DA 10.2018.650.1 Mixed use development, Jonson Street, Byron Bay

ATTACHMENTS TO COUNCIL REPORT

ADDENDUM 1: SUMMARY FOR RESPONSE TO COUNCIL'S INFORMATION REQUEST – DECEMBER 2018

ADDENDUM 2: SUMMARY FOR RESPONSE TO COUNCIL'S INFORMATION REQUEST – MAY 2019

Date: 18/06/2020	Drawing Name: Ground Floor Swept Path Assessment - B99 Manoeuvring - Curved Roadway Entrance	<div>NOT FOR CONSTRUCTION</div> <div>0 4 8 12 16m Scale 1:400 (A3)</div>	<div>BITZIOS consulting</div> <div>Sheet 6 Version 001</div>
Project No: P3829	Project Name: 106 Jonson Street

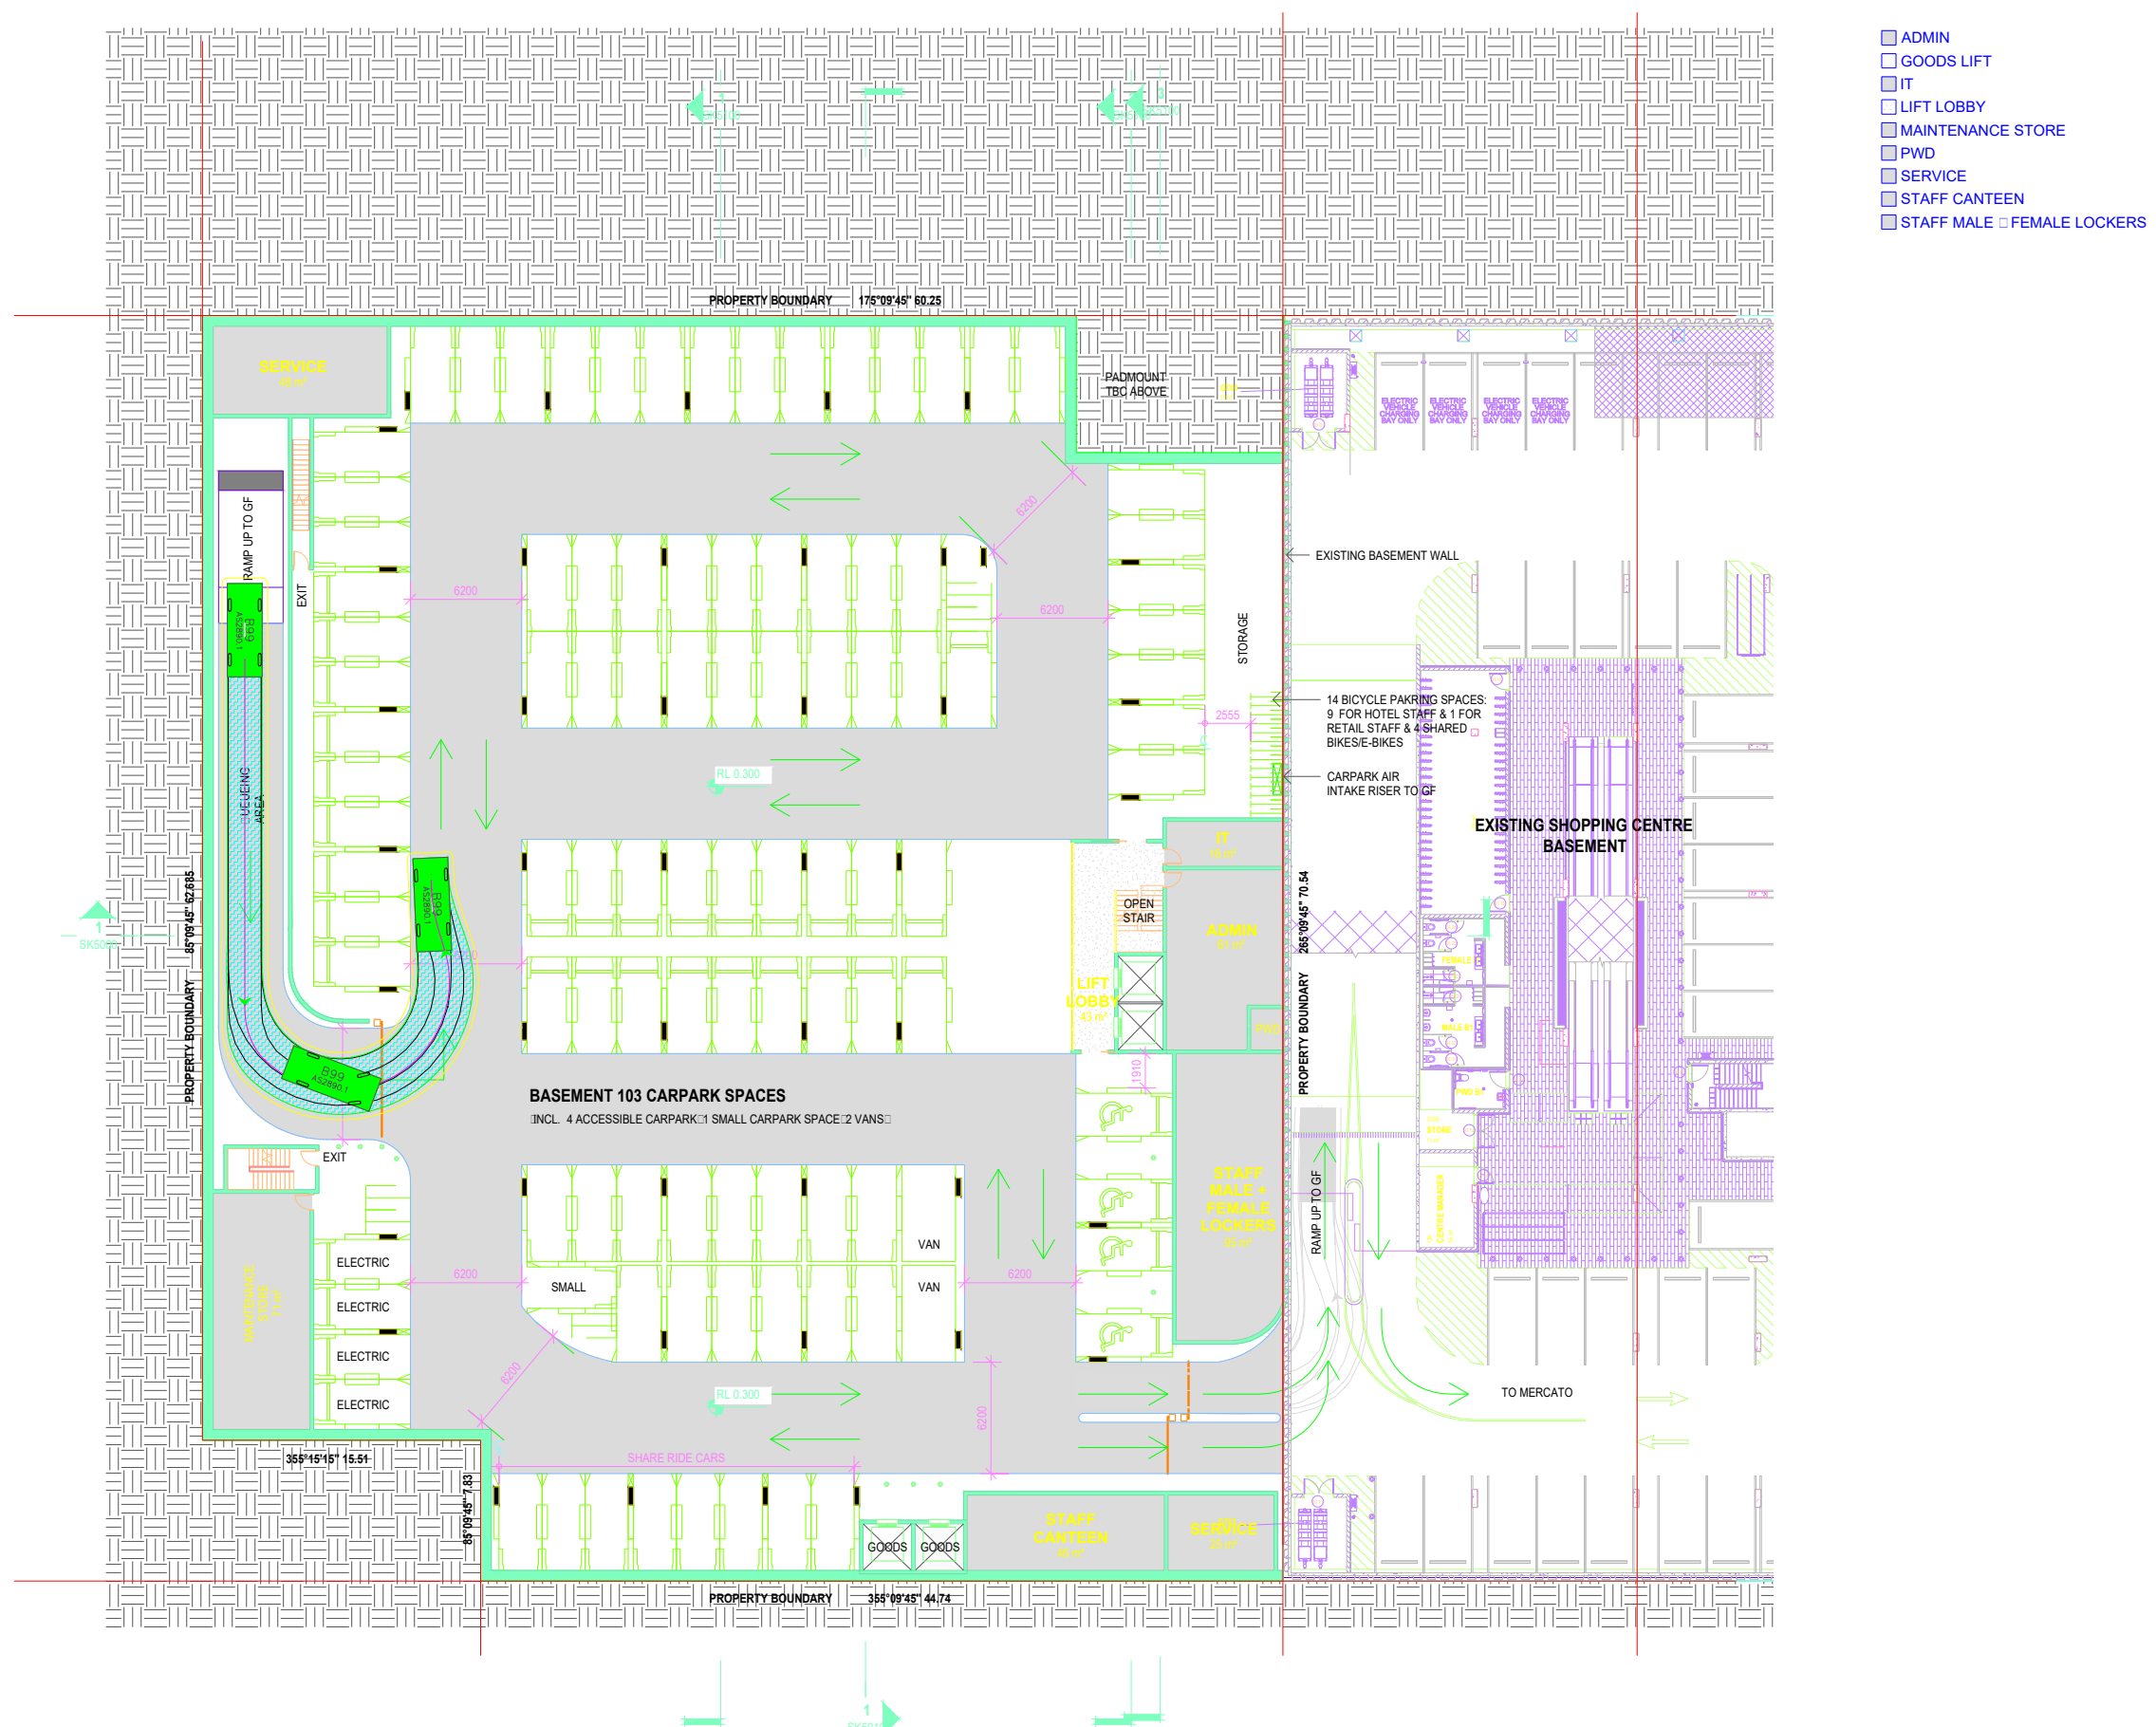
Amend the curved circulation roadway in accordance with Table 2.2 and Figure 2.9 of AS2890 to include the following:

Response:
